Office Action Summary

10/550,322

SANTOS LOPEZ ET AL.

FIGURE 1

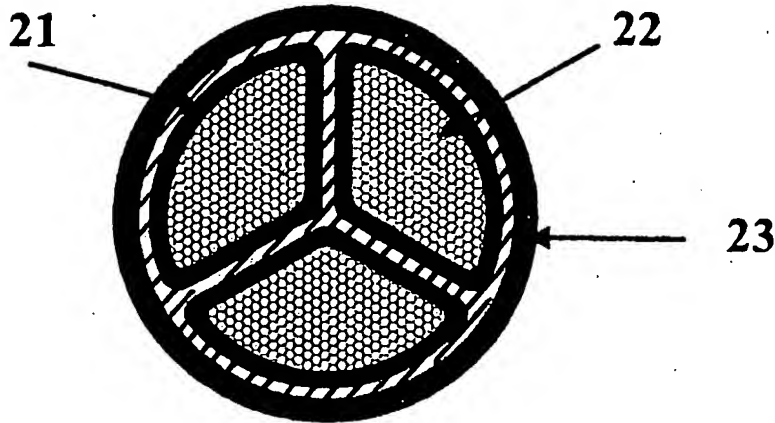
1. The drawings were received on February 12, 2007. These drawings are not approved because Figure 1 lacks the proper cross-hatching which indicates the type of materials, which may be in an invention. Specifically, the cross hatching to indicate the conductive and insulative materials is improper. The applicant should refer to MPEP Section 608.02 for the proper cross-hatching of materials. Correction is required.

NOT
APPROVED
WJH/MTJ
8/27/07

In addition to Replacement Sheets containing the corrected drawing figure(s), applicant is required to submit a marked-up copy of each Replacement Sheet including annotations indicating the changes made to the previous version. The marked-up copy must be clearly labeled as "Annotated Sheets" and must be presented in the amendment or remarks section that explains the change(s) to the drawings. See 37 CFR 1.121(d)(1). Failure to timely submit the proposed drawing and marked-up copy will result in the abandonment of the application.
